Point Beach Nuclear Plant, Units 1 and 2
Dockets 50-266 and 50-301
Renewed License Nos. DPR-24 and DPR-27

License Amendment Request 261
Extended Power Uprate
Response to Request for Additional Information

LICENSE AMENDMENT REQUEST 261 EXTENDED POWER UPRATE RESPONSE TO REQUEST FOR ADDITIONAL INFORMATION

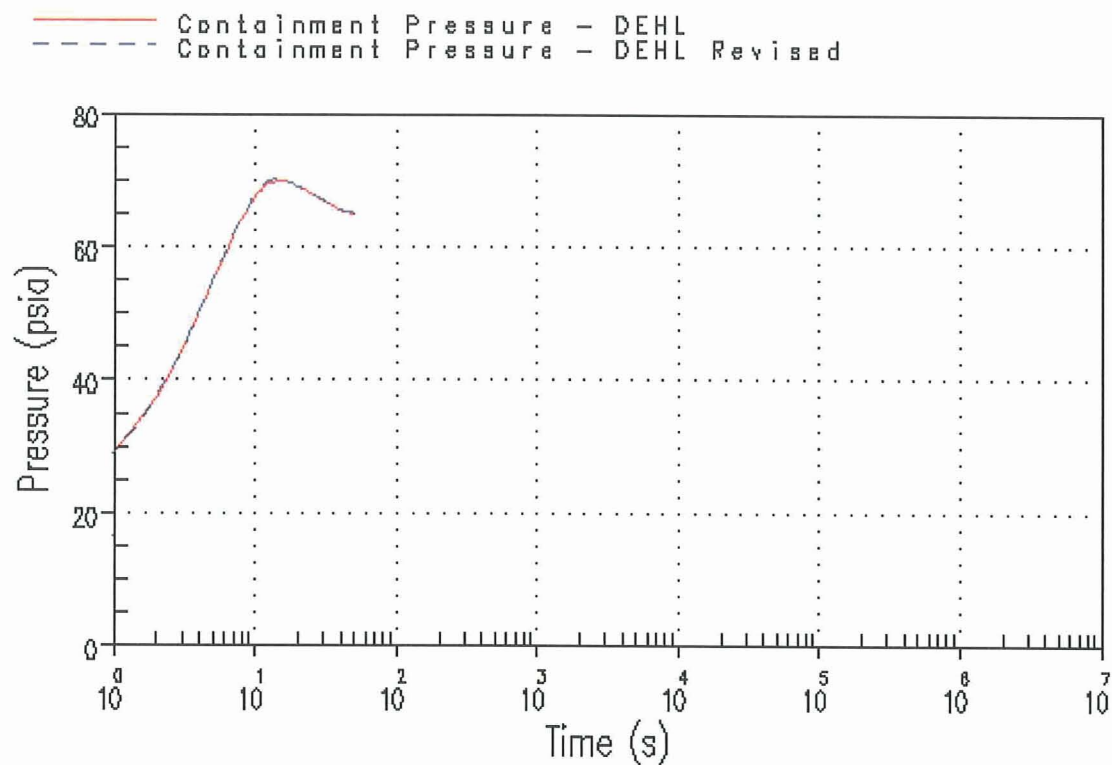
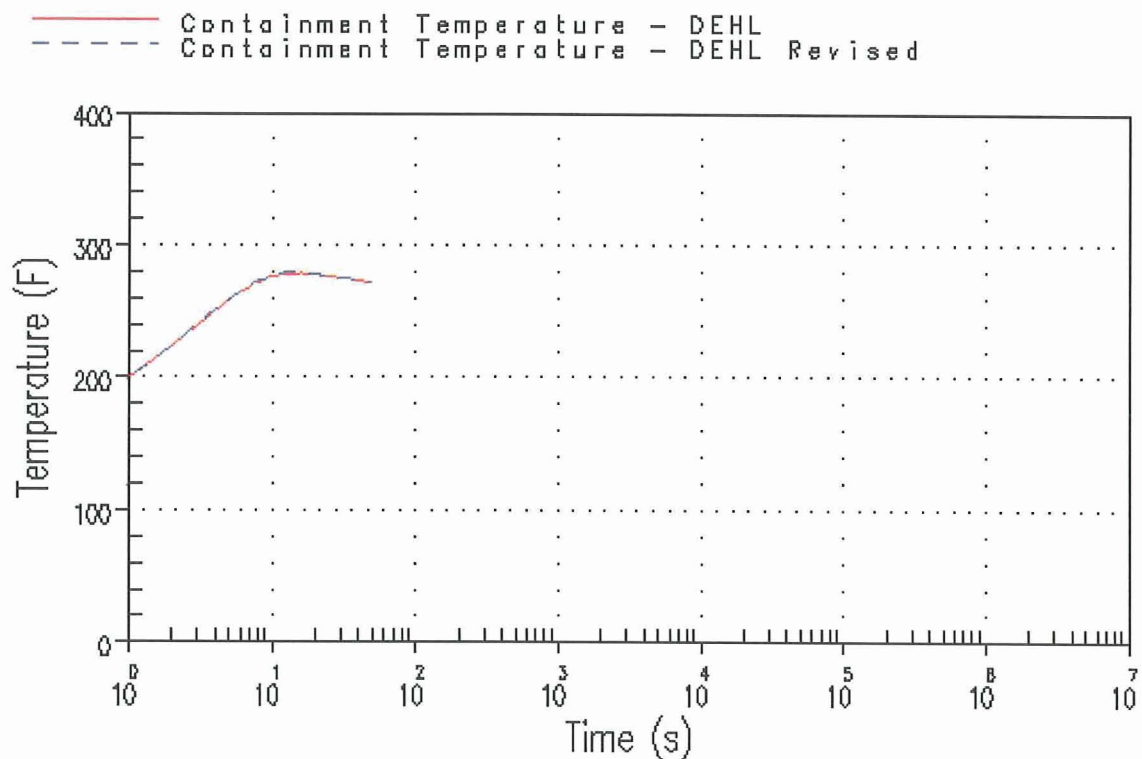
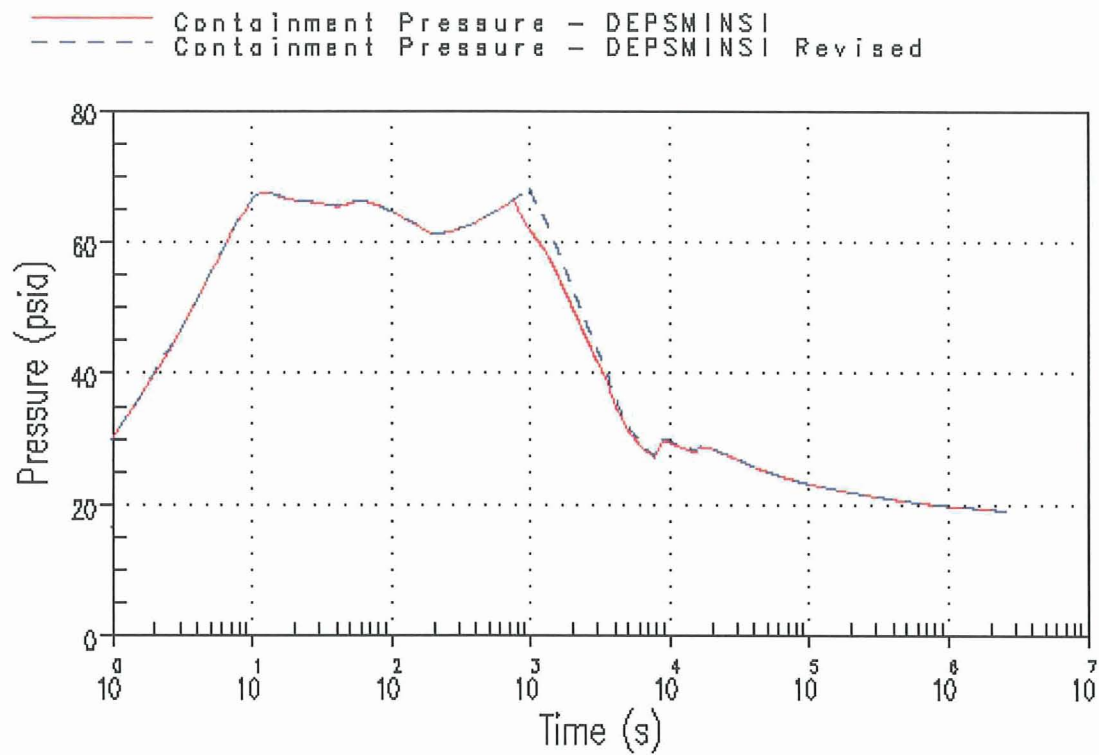
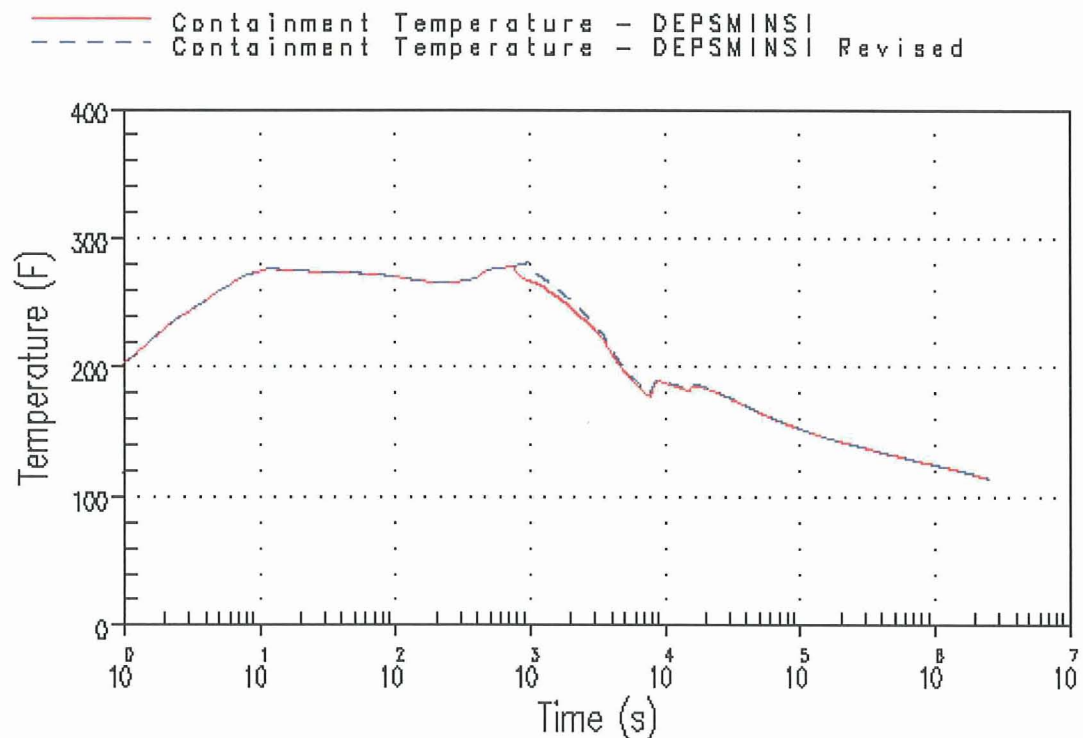
1. LR 2.6.1, Primary Containment Functional Design: The peak LOCA containment response results for temperature and pressure at EPU conditions shown in Table 2.6.1-9 of Reference (1) are increased as indicated in the revised analysis results items 1 and 2. The limiting peak containment results are associated with the main steam line break (MSLB) results shown in Table 2.6.1-9, which are not affected by the LOCA mass and energy analysis issues. In addition, the peak LOCA containment pressure and temperature values are still well below the containment design values of 74.7 psia and 286°F. The previous and revised LOCA containment pressure and temperature profiles for the double ended hot leg break (DEHL) and double ended pump suction break with minimum safety injection (DEPSMINSI) cases are shown in Attachment A, Figures 1 to 4. These figures correspond to Figures 2.6.1-1 to 4 in Reference (1).

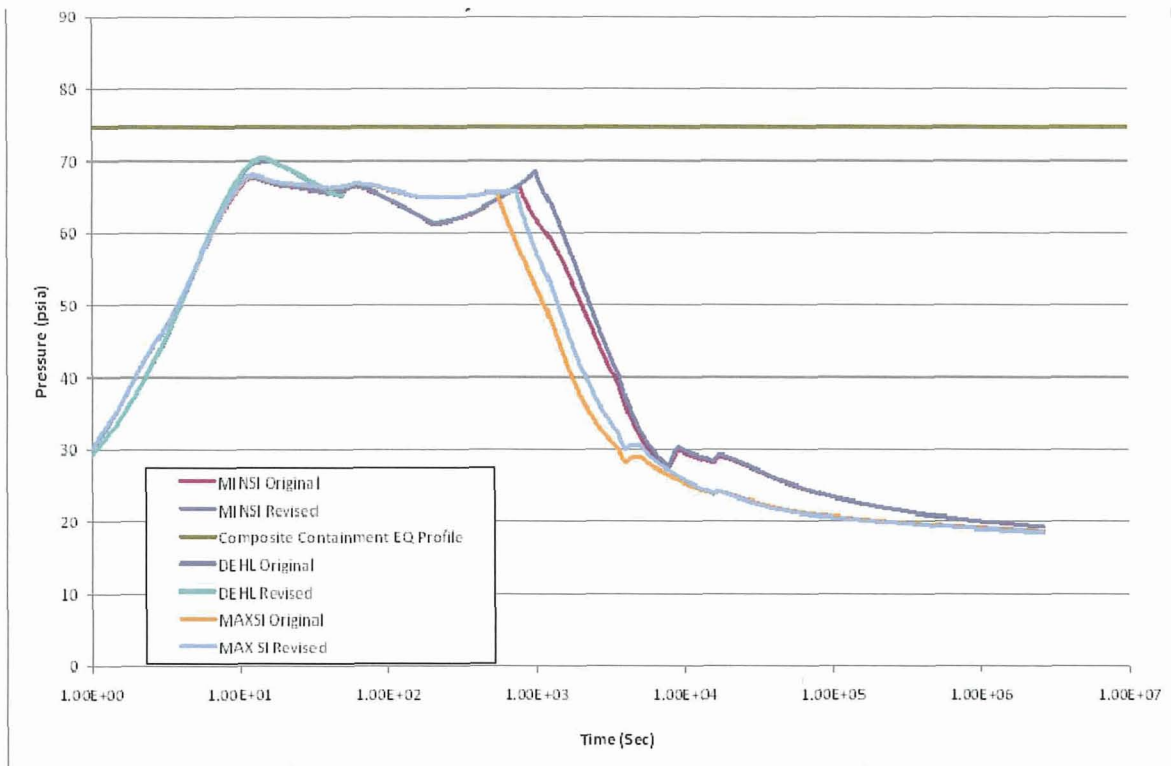
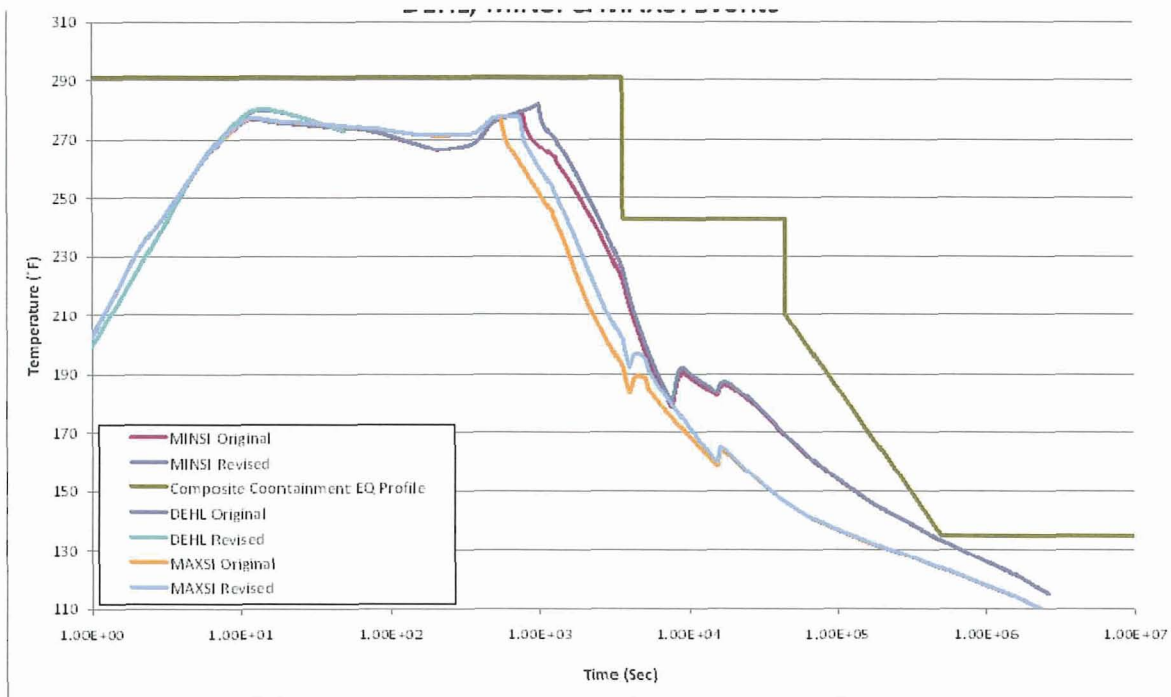
4. LR 2.3.1, Environmental Qualification (EQ) of Electrical Equipment: The increased LOCA temperature and pressure profiles did not affect the required margins for EQ of electrical equipment inside containment. Comparison of the previous and revised containment LOCA EPU temperature and pressure profiles to the composite containment EQ profiles are shown in Attachment A, Figures 5 and 6. These figures correspond to Figures 1 and 2 in the NextEra Response to NRC RAI EEEB-5 (Reference 2). The electrical equipment remains qualified with applicable margins as recommended by IEEE-323-1974.
